**Subject: Wetlands & Stormwater Review for
Goodridge Estates 40B Project, Lancaster, MA**

As requested, I am submitting an initial peer review for the Goodridge Estates Chapter 40B project application, proposed on land on Sterling Road in Lancaster, MA. I anticipate that I will have further comments as the technical data for this proposal develops. Please note that I walked the perimeter of the site on January 10, 2019, as well as observed adjoining areas.

Figure 1. 1997 USGS map of vicinity; see Fig. 2 below for MassGIS view.

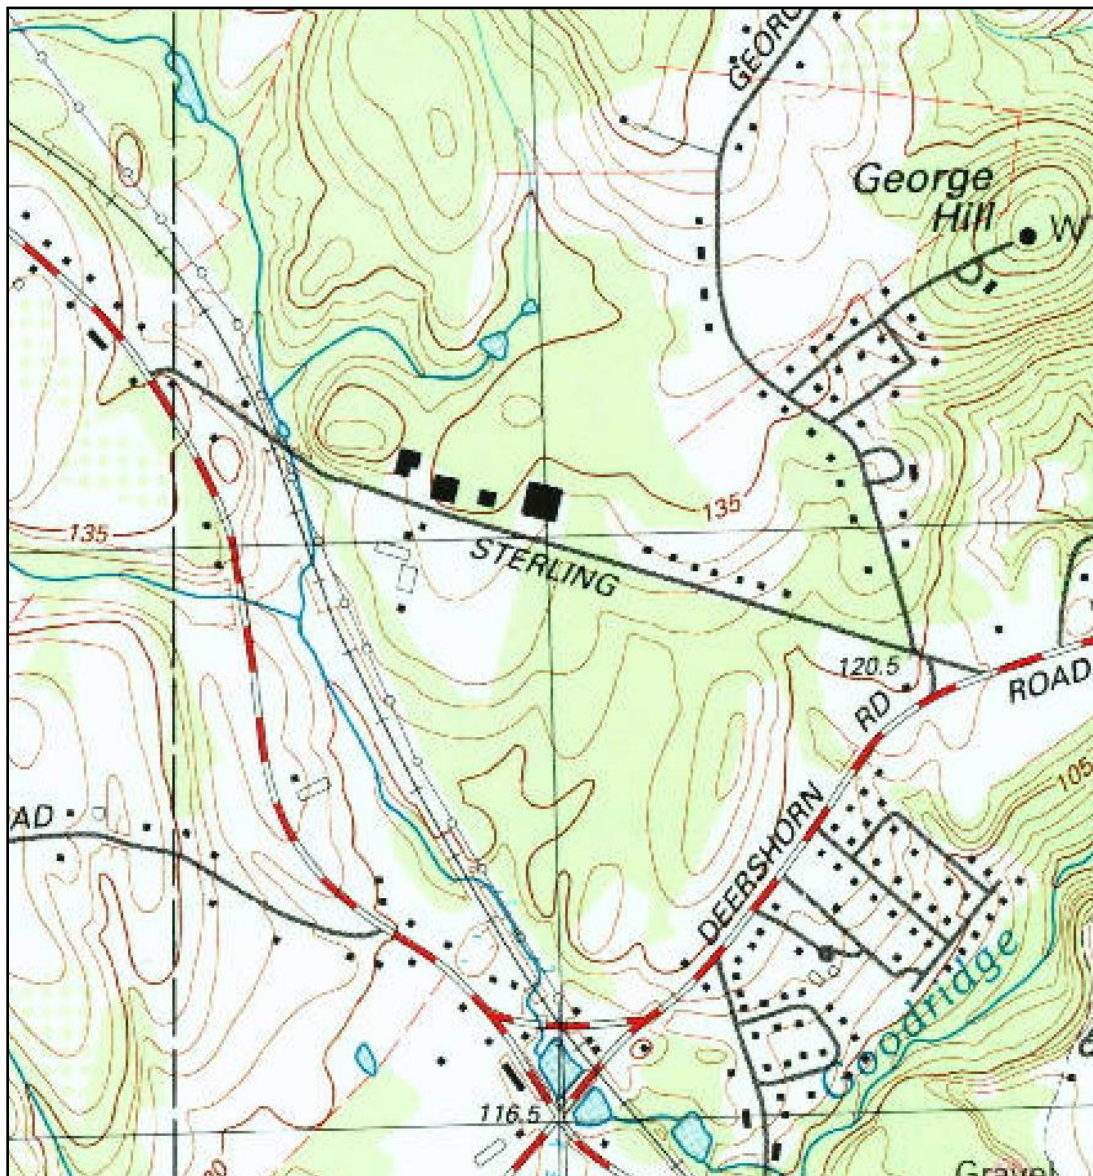
The applicant's mapping shows a stream within a portion of the BVW on site. The plans indicate that the stream is intermittent. The WPA (see 310 CMR 10.58(2)(a)) defines a river as being *perennial* through a hierarchy that I summarize below:

- The stream on the project site is not shown as perennial on the current USGS quad map, and
- The stream does not have a watershed area greater than or equal to one square mile.

Therefore, I concur the stream is not a WPA-protected perennial stream, and has no associated Riverfront Area.

Figure 2. MassGIS view of overall site.

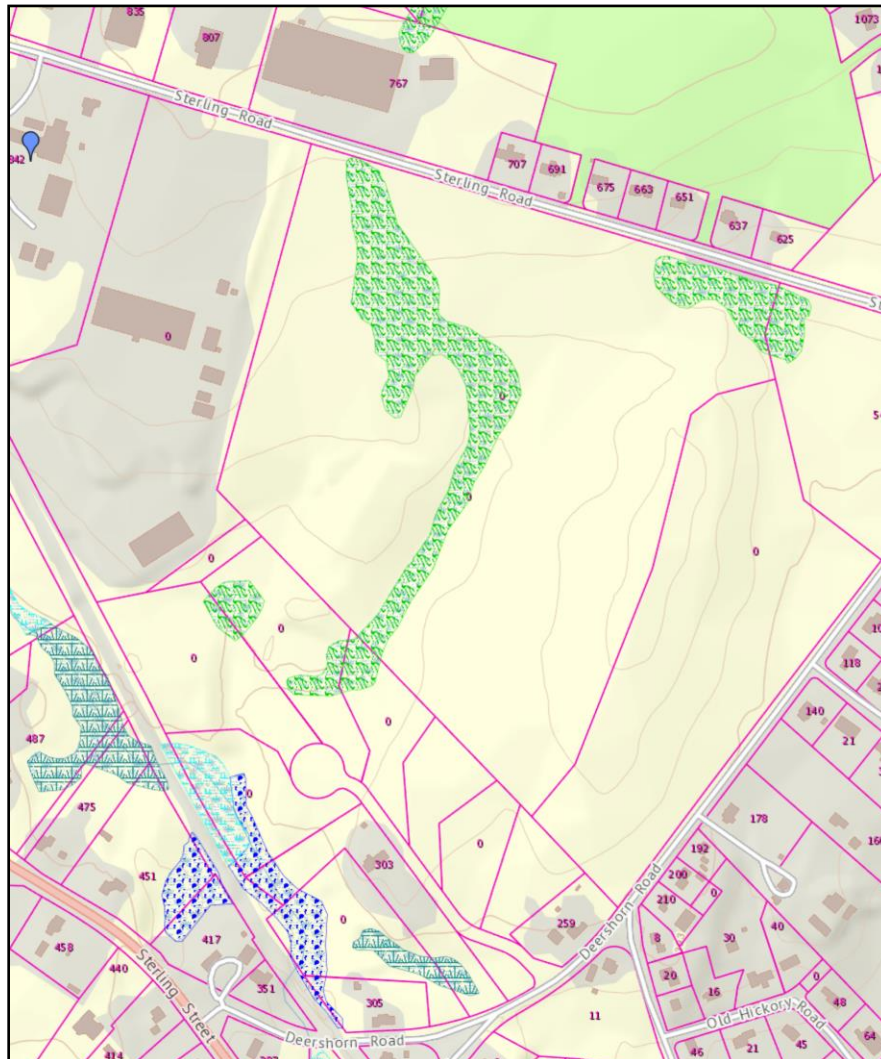
- The wetlands shown on the plans are not consistent with wetland areas shown on MassGIS mapping (please see Figure 2 below). MassDEP has identified an extensive area of wetlands in the front northeast corner of the project beside Sterling Road. The plans show far less

wetlands than MassDEP indicates, which in my experience, is unusual. In practice, the MassDEP GIS mapping usually minimizes the extent of wetlands, and field confirmation often determines that far more wetlands exist than indicated on the state mapping.

- If the MassDEP GIS mapping is accurate, the project proposes roads, parking and housing within the wetlands to an extent not permitted under state law.
- Based on the existence of nearby vernal pools that lie offsite but within a short distance of the project, the project site may contain active vernal pools. At least two species of spotted salamanders have been photo documented in spring of 2018 along Deershorn Road to the immediate southeast of the project. The site is likely habitat for wood frogs, a species also associated with vernal pools.

Figure 3. US NOAA 2019 Point Precipitation Atlas, Lancaster, MA.

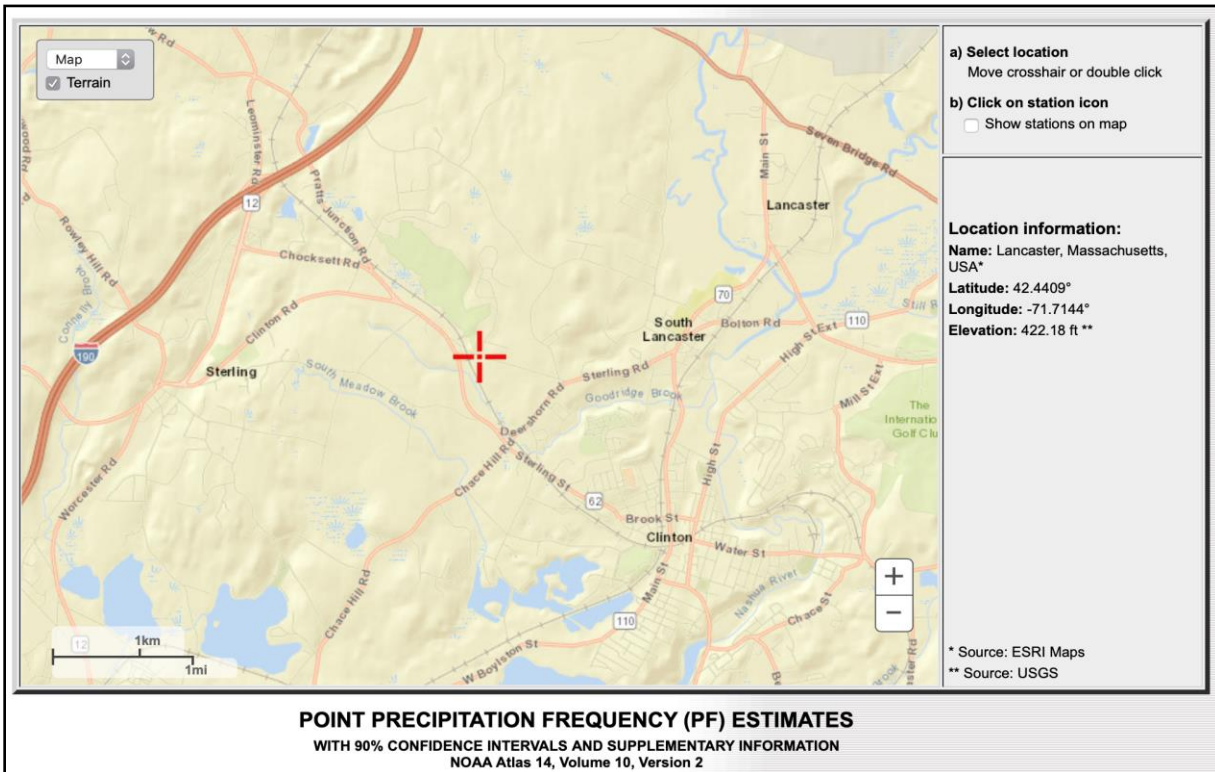
- The precipitation runoff numbers used in the HydroCAD calculation are apparently from the TP-40 atlas. The engineer indicates the 24-hour storm to be 7.0-inches. The NOAA Atlas 14--issued specifically to supersede the now obsolete TP-40--indicates a 100-year storm of 7.68 inches (see Figures 3 and 4 below). Use of a smaller rain event may lead to inadequately sized pipes and stormwater detention basins, among other impacts.

- The 7-inch storm used by the applicant is currently permitted by MassDEP, but best engineering practice dictates that scientifically accurate rainfall quantities be used. Calculations should meet regulatory requirements at a minimum, but should use updated data when precipitation quantities are known to be larger than required by regulation. All the HydroCAD stormwater calculations need to be rerun using scientifically valid data.

- All calculations should be rerun to reflect accurate watershed areas and precipitation volumes.
